Access Compliance Report

Public Rights-of-Way

Intersection ID: 53916	Main Street: TULOCAY_LN	Cross Street: BRITTONDALE_LN	Location: E
ADA ID: 251DEEA22A4D	Ramp Type: PerpDiag	Initial Pass/Fail: Fail	Overall Compliance: No
Codes/Mitigation Info/Possible Solution		Field Measurements/Component Compliance	
Severity Score: 36.25

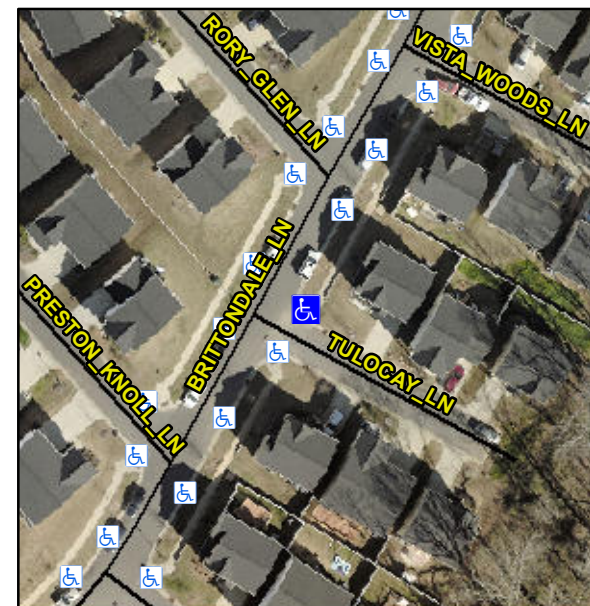
Not Found, R304.5.1, R304.5.3

Compliance	Description	Data	Compliance	Description	Data
N/A	Ramp Length (in)	97.0	Yes	Ramp Slope (%)	7.2
No	Ramp Width (in)	28.0	No	Ramp XSlope (%)	2.2
N/A	Flare Type LT	N/A	N/A	Flare Type RT	N/A
N/A	Flare Slope LT (%)	N/A	N/A	Flare Slope RT (%)	N/A
N/A	Flare Traversable LT?	N/A	N/A	Flare Traversable RT?	N/A
N/A	Landing Length (in)	N/A	N/A	DWS Provided?	N/A
N/A	Landing Width (in)	N/A	N/A	DWS Contrast?	N/A
N/A	Landing Slope (%)	N/A	N/A	DWS Length (in)	N/A
N/A	Landing X Slope (%)	N/A	N/A	DWS Full Width?	N/A
N/A	Landing Curb? (Y/N)	N/A	N/A	DWS Offset (in)	N/A
N/A	Shared Landing?	N/A			
N/A	Gutter Ponding?	N/A	N/A	Gutter Slope (%)	N/A
N/A	Gutter Lip Ht (in)	N/A	N/A	Gutter X Slope (%)	N/A
N/A	Painted X Walk1?	No	N/A	Painted X Walk2?	No
	X Walk 1 Direction	To NE		X Walk 2 Direction	To SW
N/A	X Walk 1 Width (in)	N/A	N/A	X Walk 2 Width (in)	N/A
	X Walk 1 Slope (%)	1.4		X Walk 2 Slope (%)	0.7
	X Walk 1 X Slope (%)	2.0		X Walk 2 X Slope (%)	0.3

Remove & Replace Curb Ramp With Two New Directional Ramps or Equivalent.
